MONTGOMERY COUNTY HISTORIC PRESERVATION COMMISSION
STAFF REPORT

Address:	3713 Underwood St., Chevy Chase	Meeting Date:	3/11/2026
Resource:	Clark House (#35/75) Individually Listed Master Plan Site	Report Date:	3/4/2026
Applicant:	Hannah Graae & Duke Schaeffer	Public Notice:	2/25/2026
Review:	HAWP	Tax Credit:	n/a
Case Number:	1149140	Staff:	Dan Bruechert
Proposal:	Partial Demolition, Rear Addition Construction, and Fenestration Alteration

Staff recommends that the HPC **approve with three (3) conditions** the HAWP application. Final approval authority is delegated to Staff.

Figure 2: Sanborn Fire Insurance Map (1927-1963) showing a partial-width rear porch at the subject property.

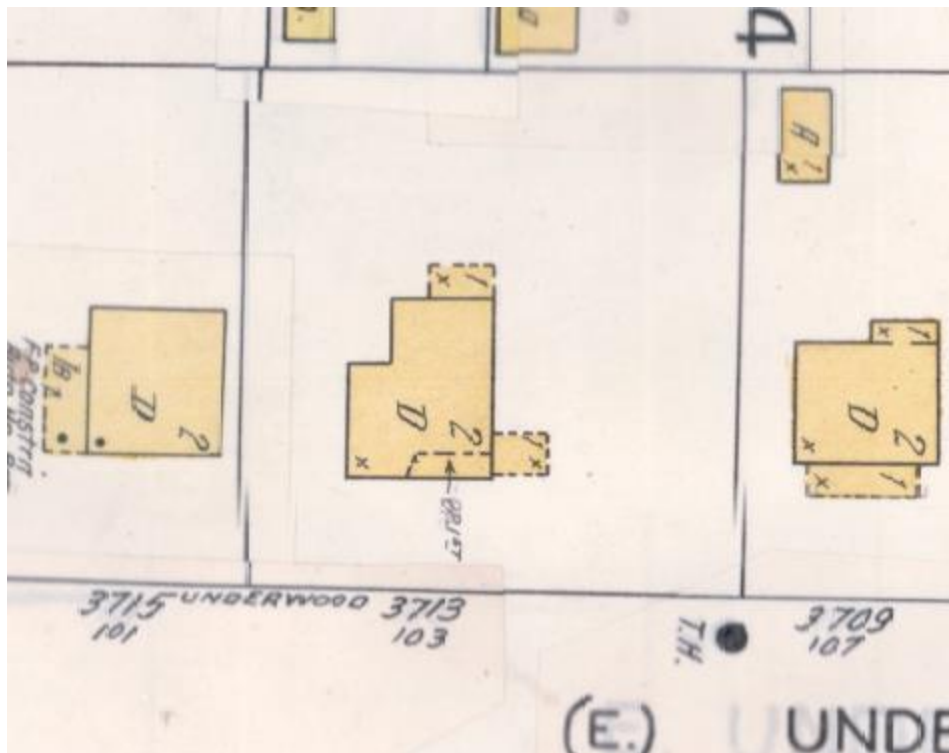
At the rear of the Clark House, there is a wood-framed screened-in porch with a shed roof. Staff records show a partial-width rear porch at the subject property, which indicates the existing porch is not in its original configuration. The applicant proposes to demolish the existing rear porch and construct a one-story addition with a walk-out basement in its place.

Based on the Sanborn Fire Insurance Map, the existing rear porch does not appear to be a historic feature. Due to the subject property's configuration, only the northeast corner of the porch is visible from the public right-of-way. Furthermore, Staff finds its simple architectural details lack much of the architectural embellishments found on the remainder of the historic house.

Staff finds the demolition of this porch will not have a substantial impact on the historic character of the house or its significant architectural features. Staff supports the removal of the rear porch under 24A-8(b)(2) and *Standard #2*.

Figure 4: Basement floorplan with the enlarged windows circled.

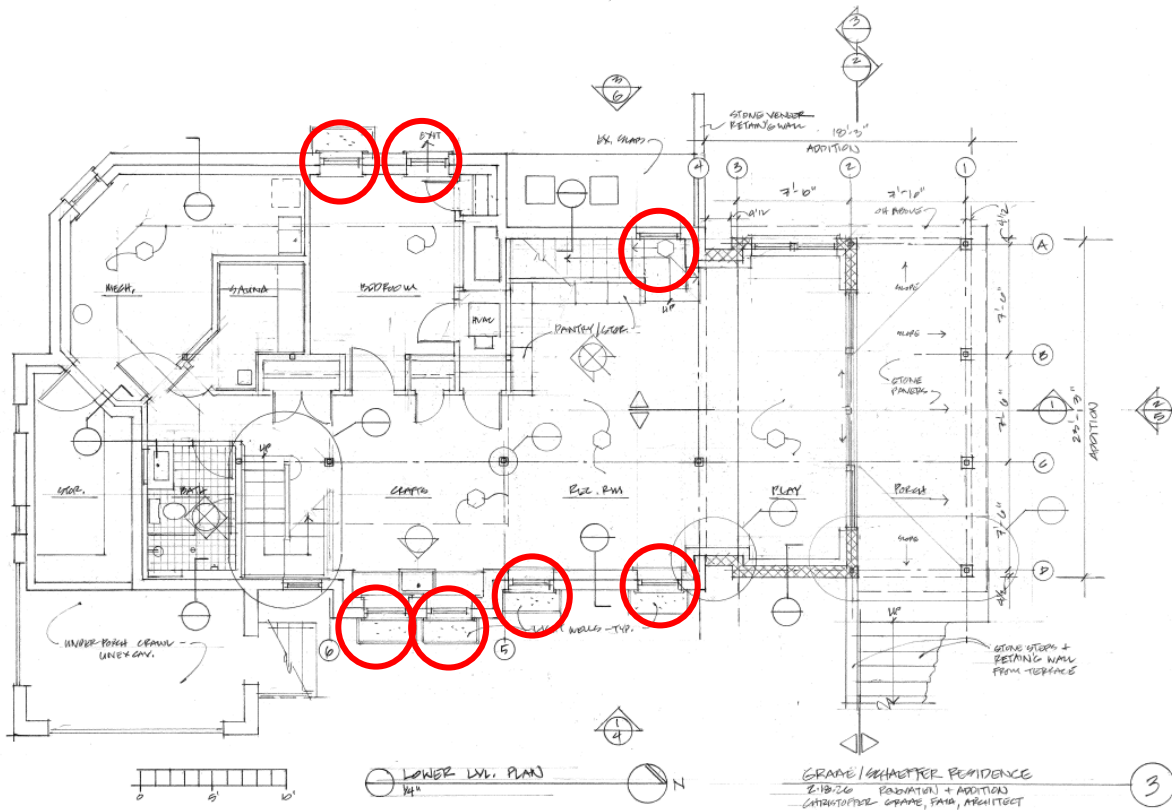
At the basement level, the applicant proposes to enlarge several existing windows and install window wells. On the east elevation, the applicant proposes to create four new windows with window wells (see *Fig. 4*, below). The existing windows on the west elevation are wood two-lite awning windows. The applicant proposes to remove and replace the existing windows, enlarge the openings, and install larger aluminum-clad two-over-two windows. A window well is proposed for the window closest to the street on the west elevation (see *Fig. 4*, below). One of the windows on the west elevation will satisfy egress requirements in a new bedroom. The proposed windows are two-over-two aluminum-clad sash windows that match the design of the historic wood windows and the windows proposed for the addition, discussed above.

The HPC has typically provided wider latitude to make changes at the basement and foundation levels, as these locations generally do not contribute to the architectural character or significance of the historic resource. Staff finds that the level of leniency is warranted in this instance, as the existing windows are utilitarian features that do not contribute to the house’s high-style Queen Anne architecture. Staff finds the proposed window design is compatible with the character of the house. The HPC generally requires wood windows to be installed on above-grade openings of Master Plan sites, but due to the reduced architectural significance of the basement-level openings, it has allowed aluminum-clad windows. Staff

finds this proposal is an appropriate use of aluminum-clad windows and recommends the HPC approve the windows under 24A-8(b)(2) and *Standard #2*.

Material and design specifications were not provided for the proposed window wells. Staff finds that because window wells are below-grade features, they are likely to have a minimal impact on the character of the Master Plan Site. Staff encourages the HPC to add a condition to the approval of this HAWP that requires the applicant to submit detailed material and dimension specifications for the proposed window wells before Staff issues the final HAWP approval documents. With the recommended condition, Staff finds the proposed basement windows and window wells are appropriate under 24A-8(b)(2) and *Standard #2*.

1. Detailed material specifications for the doors and windows must be submitted to ensure they are consistent with the square profile simulated divided lites with spacer bars for review and approval before the issuance of the final HAWP approval documents.
2. A stone specification for the proposed retaining walls needs to be submitted for review and approval before issuance of the final HAWP approval documents.
3. Material specifications and dimensions for the proposed window wells must be submitted for review and approval before the issuance of the final HAWP approval documents;

Figure 3: Perspective view of the proposed addition from the northeast.

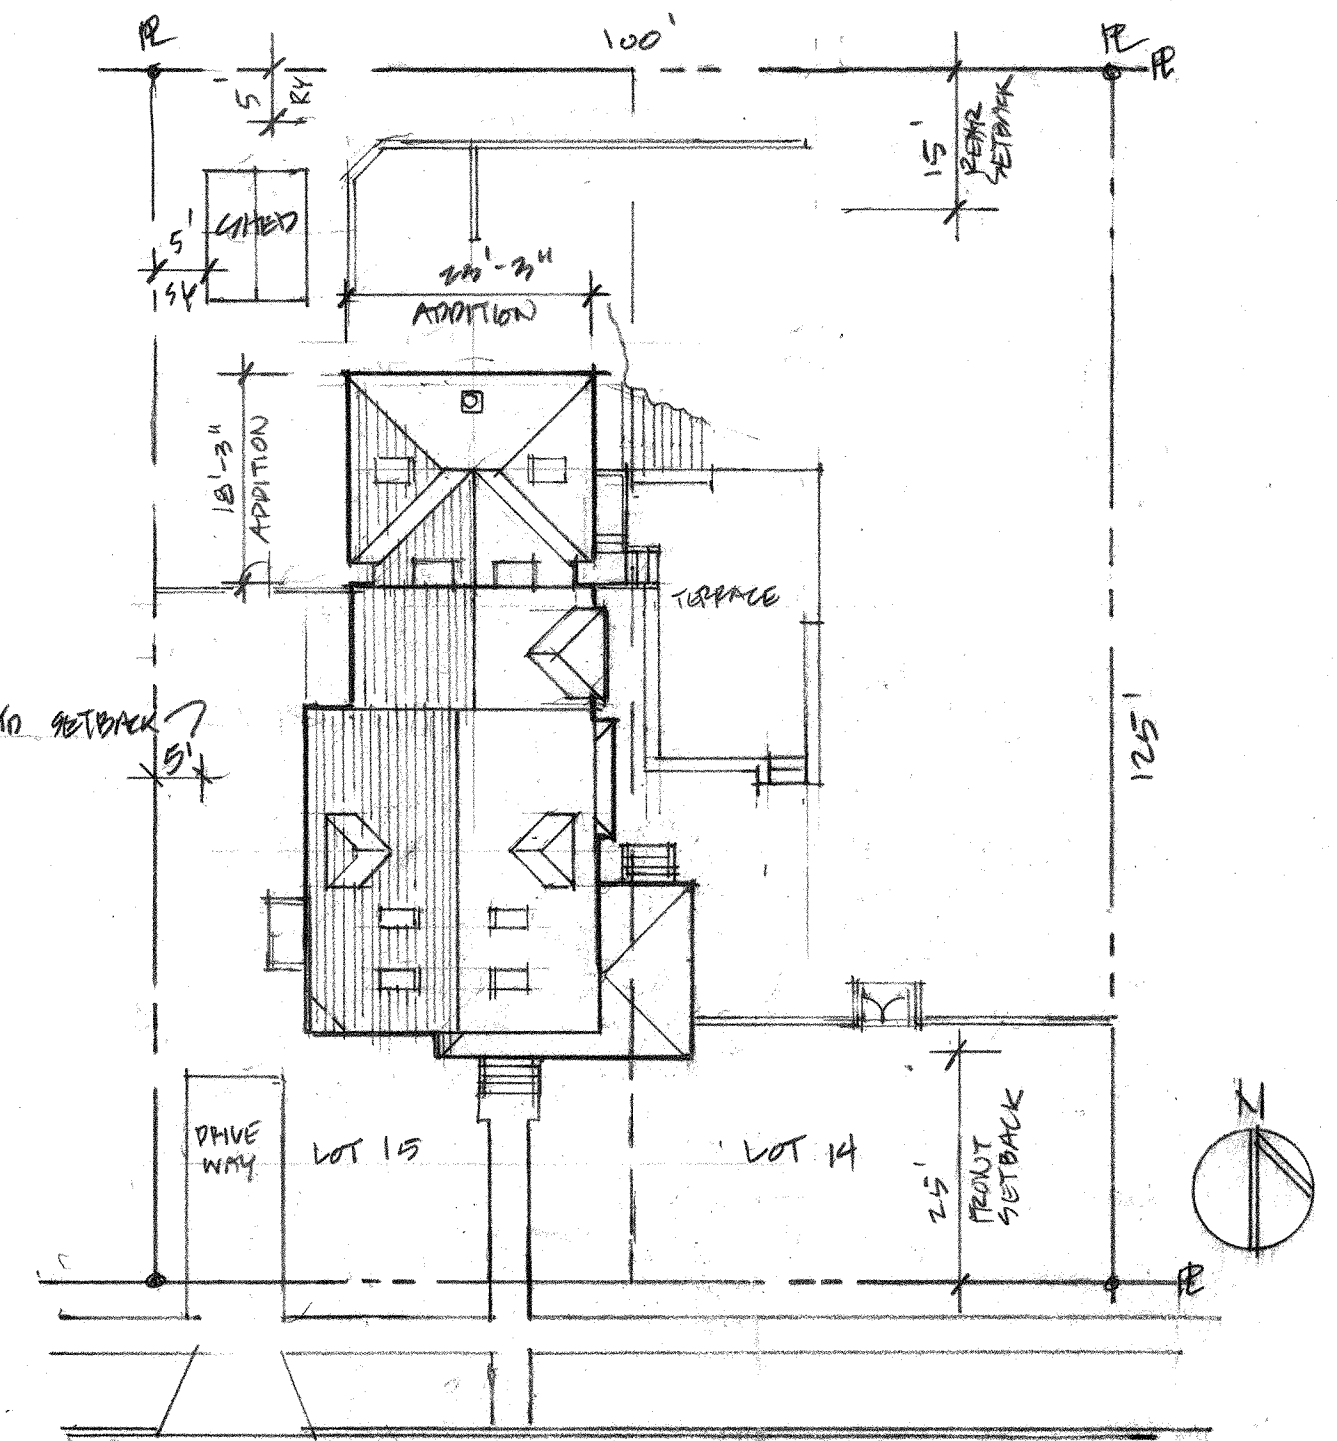
Staff finds the addition, located behind the existing house, is in a location that will limit its visibility and not visually compete with the historic architecture. Staff further finds that the side wall plane insets help the historic building to retain its primacy. The one-story form and lower-pitched hipped roof ensure the mass of the addition does not detract from the larger, vertically oriented historic house. Staff finds the size, placement, and massing of the addition are compatible with the character of the existing house and are consistent with 24A-8(b)(2) and *Standards* #2, #9, and #10.

The materials proposed for the building addition, which largely consist of aluminum-clad wood windows and doors with interior spacer bars, architectural shingles, paintable PVC trim, and painted parged block, are appropriate for additions and new construction in the environmental setting of Master Plan Sites. The HPC has consistently determined that these materials are acceptable substitutes for traditional building

materials. As a specification for the windows and doors was not provided, Staff recommends the HPC add a condition requiring the submission of this information for Staff review and approval before the issuance of the final HAWP approval documents. Staff finds the wood posts and brick chimney are also appropriate under *Standards #2* and *#9*.

With the recommended condition Staff finds addition is consistent with 24A-8(b)(2) and *Standards #2*, *#9*, and *#10*.
